ADDENDUM NO. 1
TO THE CONTRACT DOCUMENTS

Date: May 25, 2015
Project No.: 497074

CROSTOWN WATER TREATMENT PLANT IMPROVEMENTS BID #960-B
FAYETTE COUNTY WATER SYSTEM
FAYETTE COUNTY, GEORGIA

AS NOTED	
VERIFY SCALE	
BAR IS ONE INCH ON ORIGINAL DRAWING.	
DATE	MAY 2015
PROJ	497074
DWG	10-E-01
SHEET	29 of 73

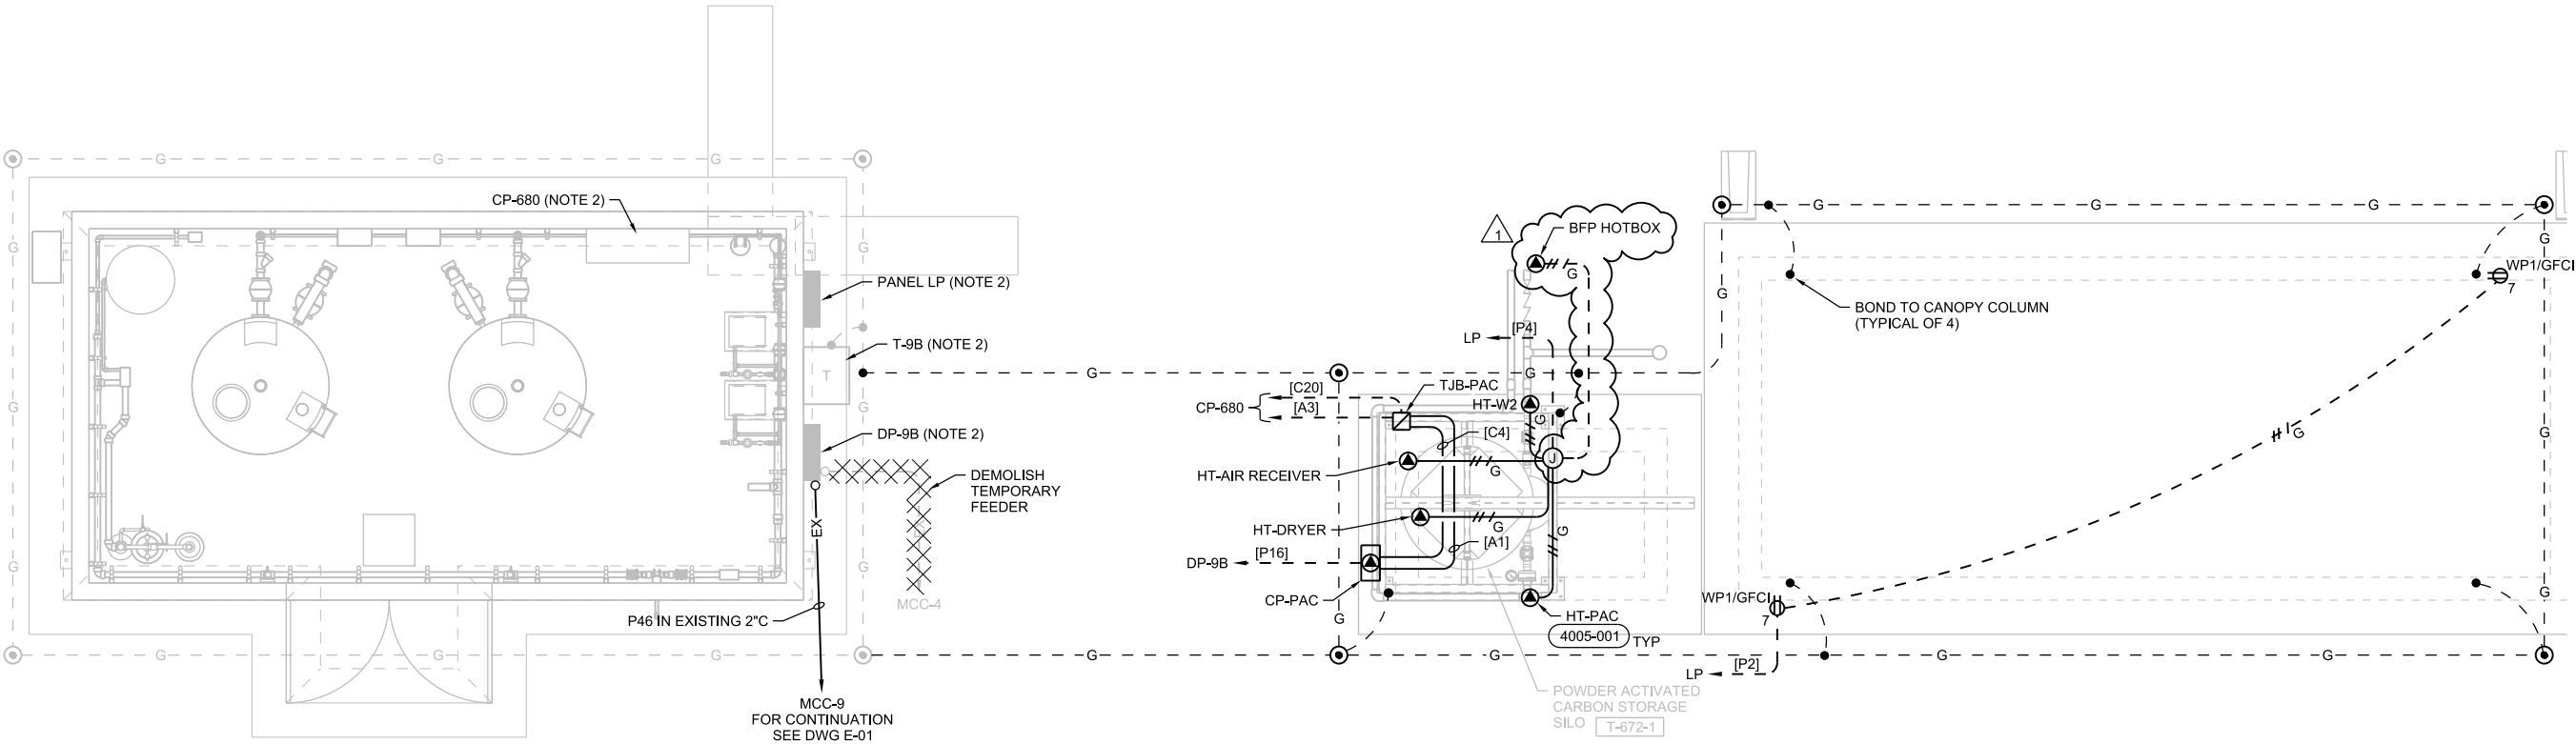
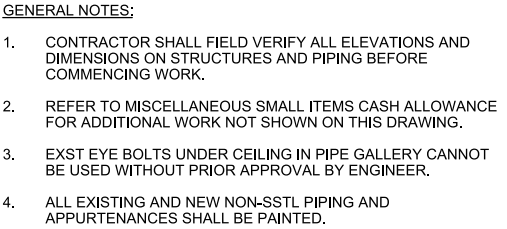
3. Drawing 10-E-01 grid location 4B, ADD power to hotbox per revised attached.

AS NOTED	
VERIFY SCALE	
BAR IS ONE INCH ON ORIGINAL DRAWING. 0  1"	
DATE	MAY 2015
PROJ	497074
DWG	30-M-02
SHEET	46 of 73

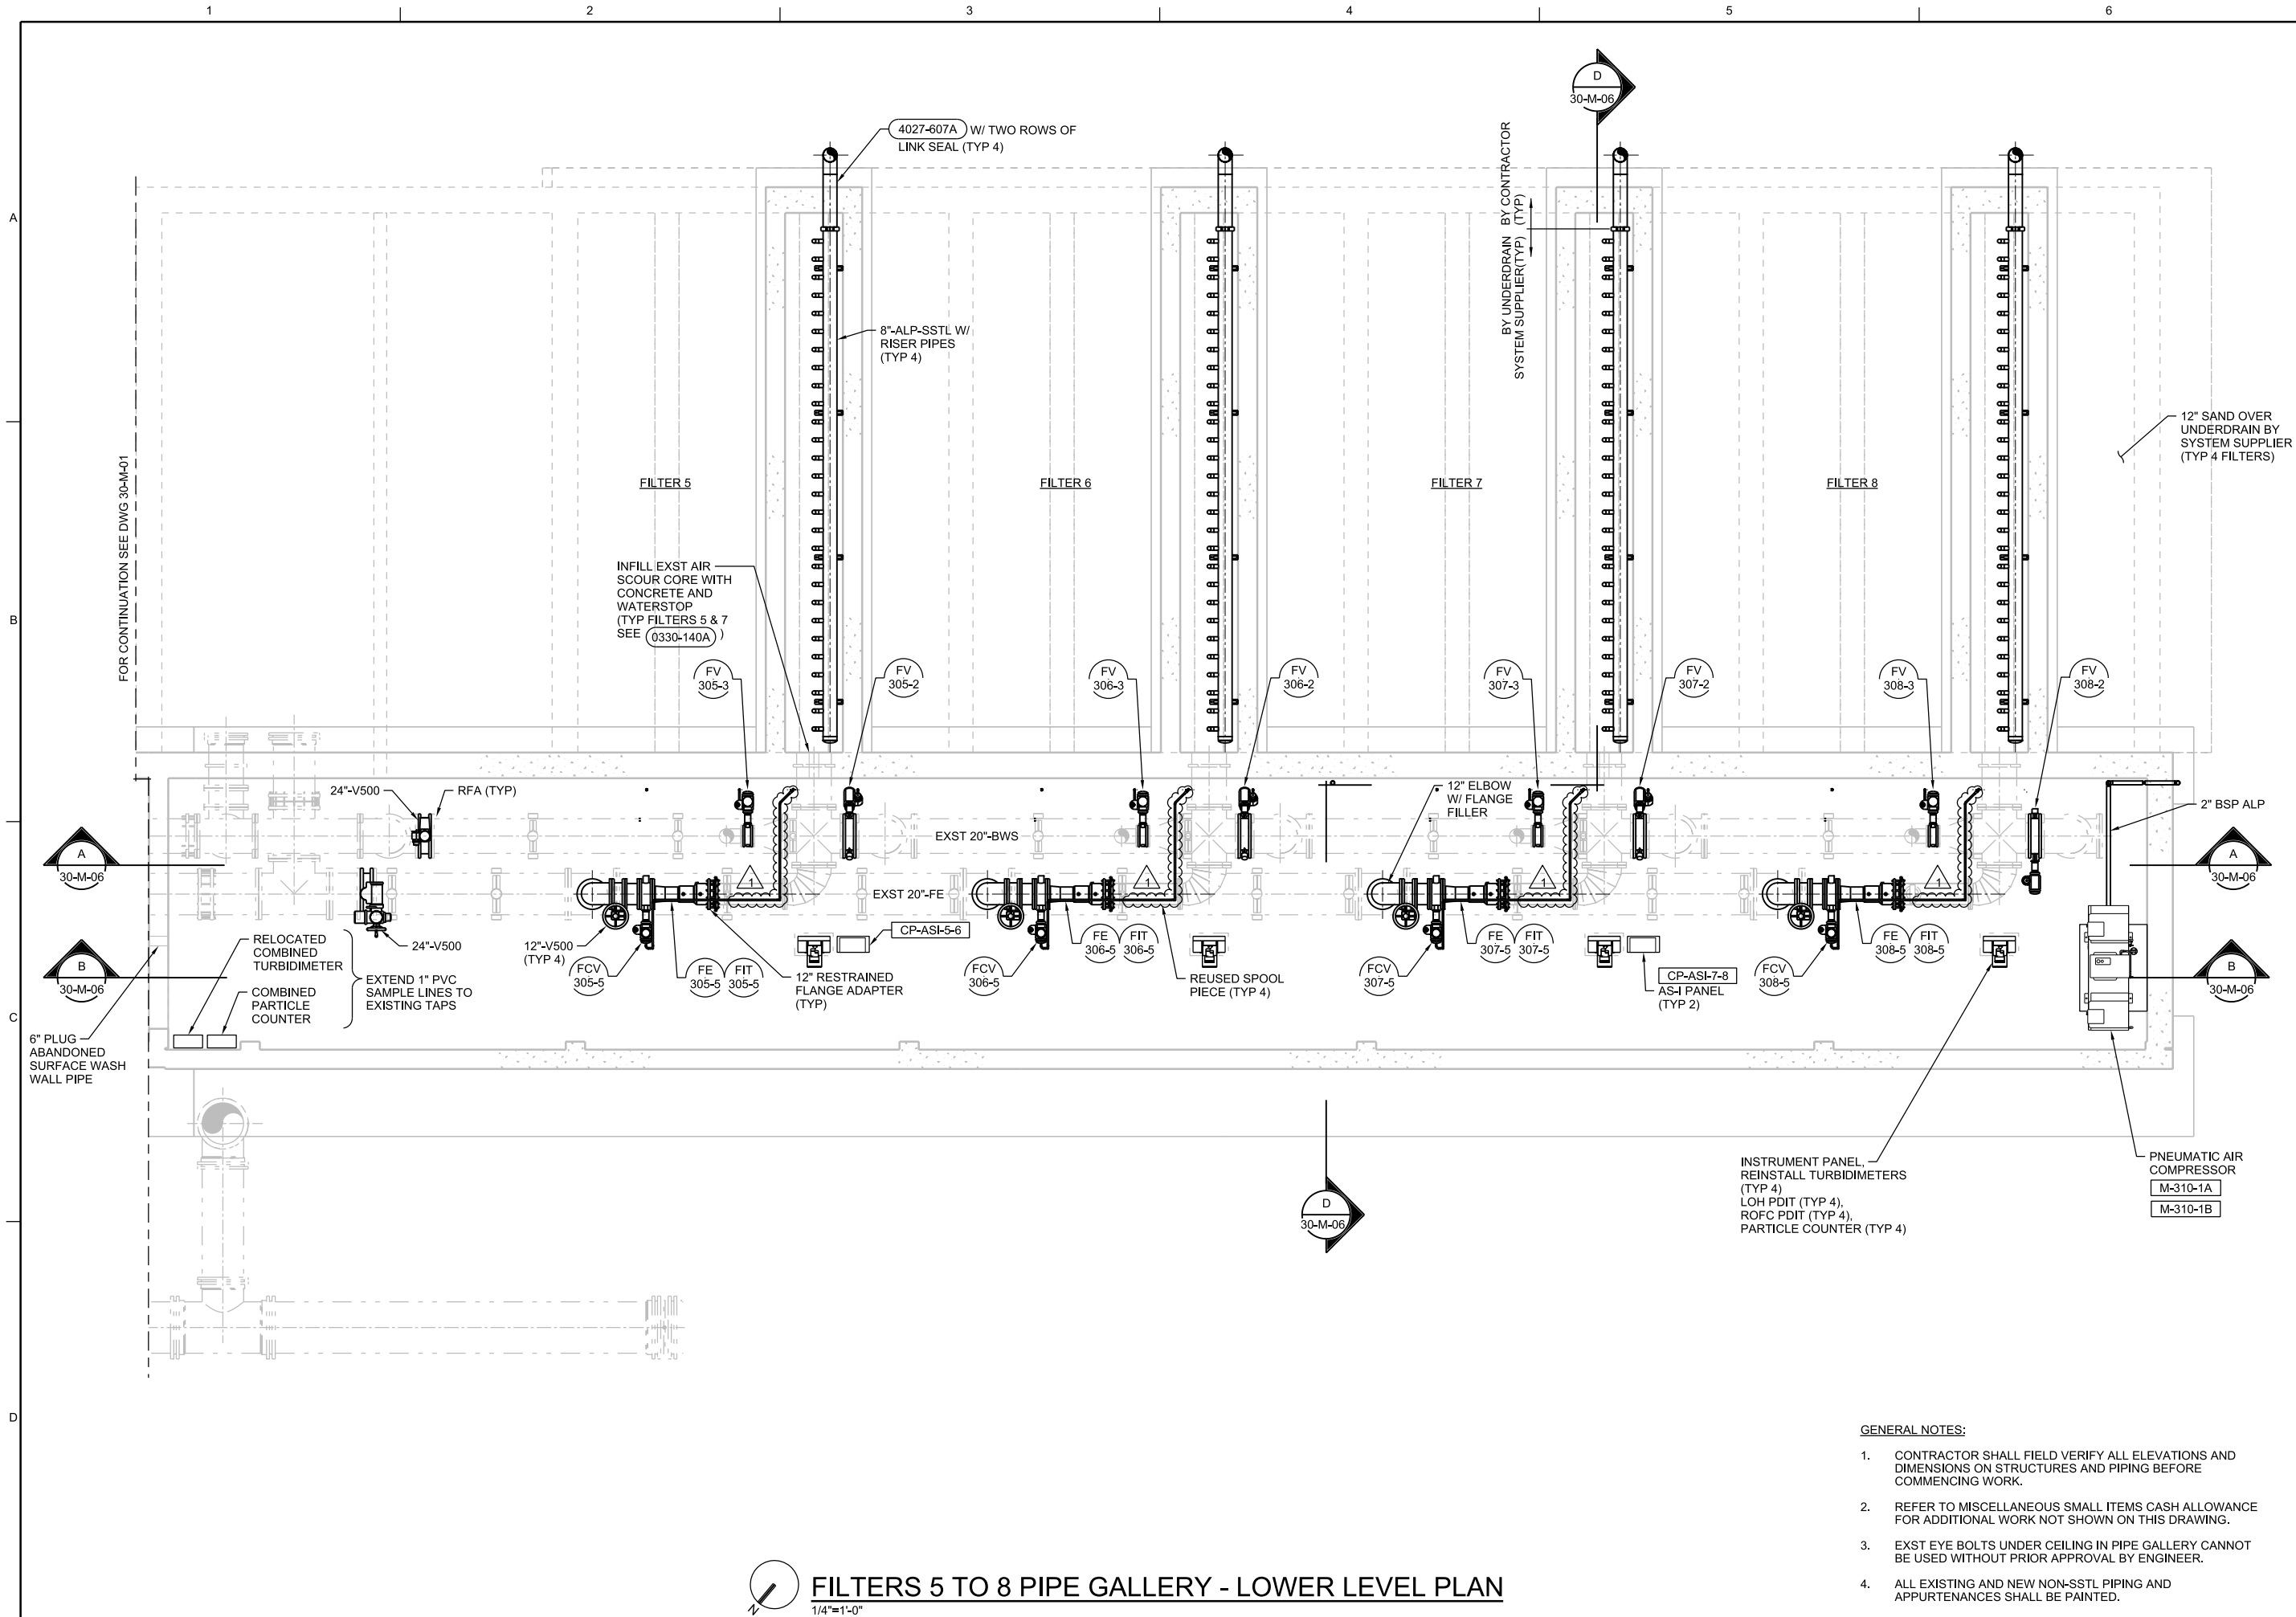
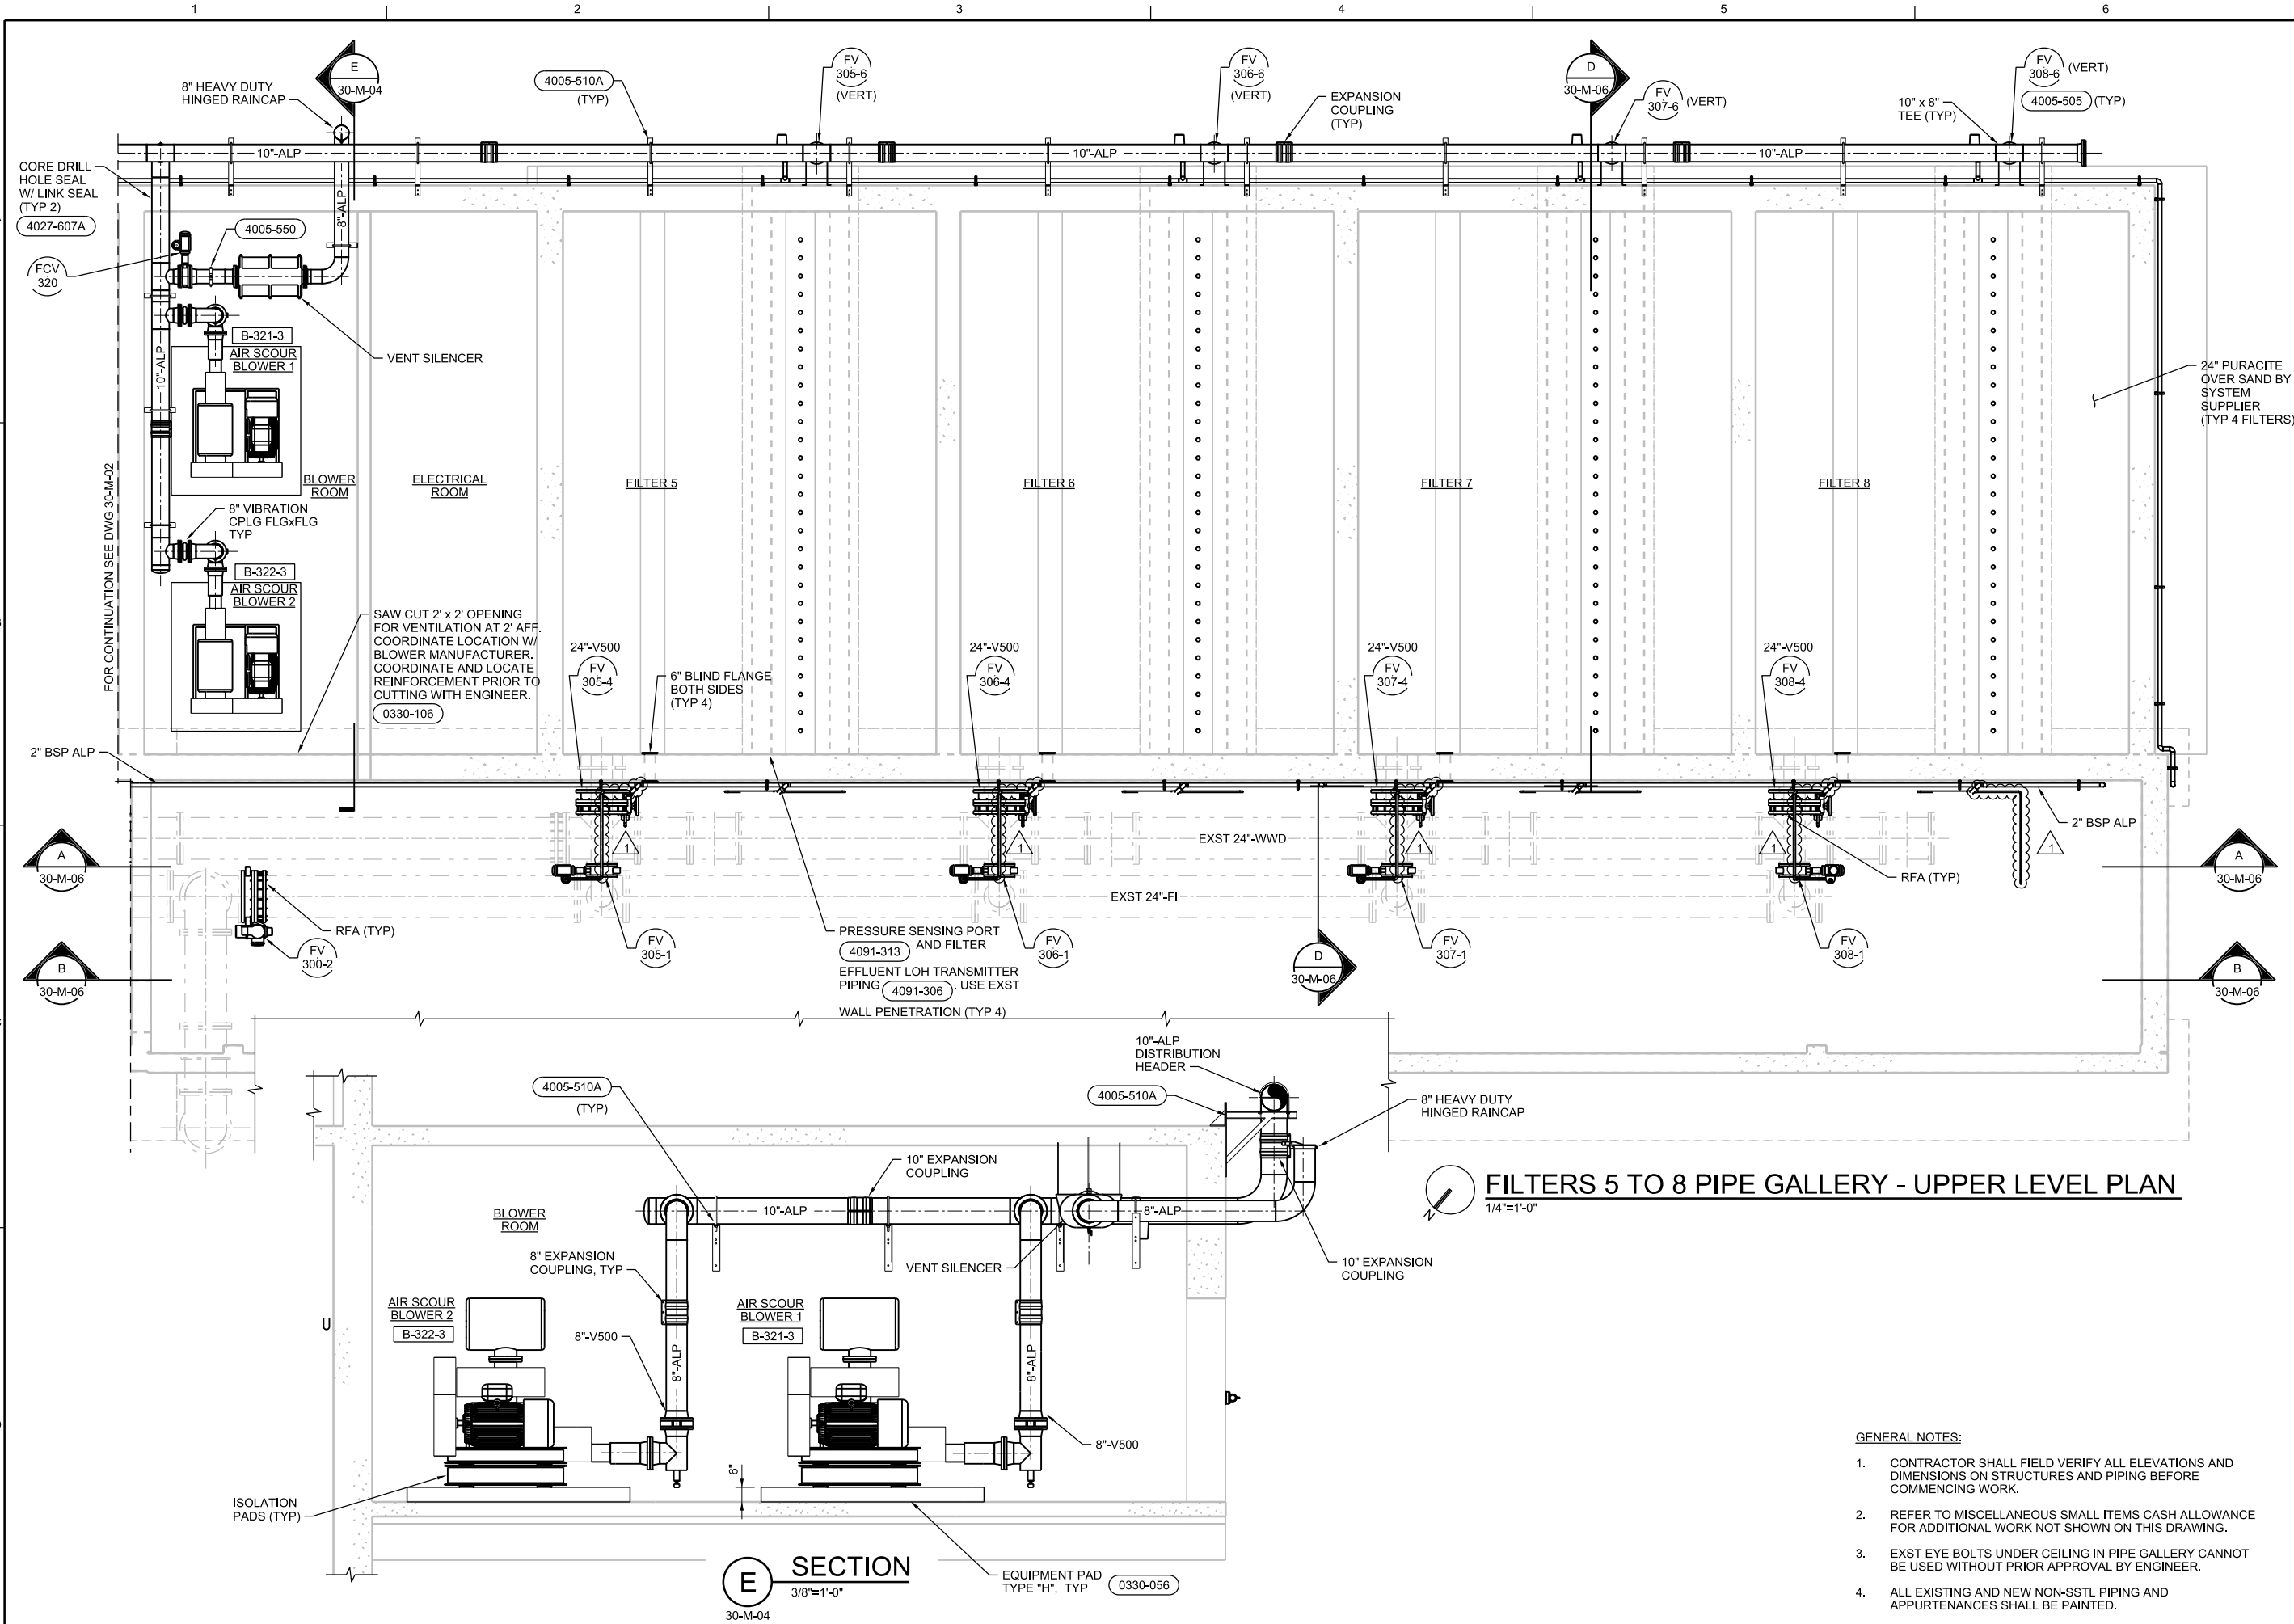
7. Drawing 30-M-02, DELETE in its entirety and REPLACE with revised attached.
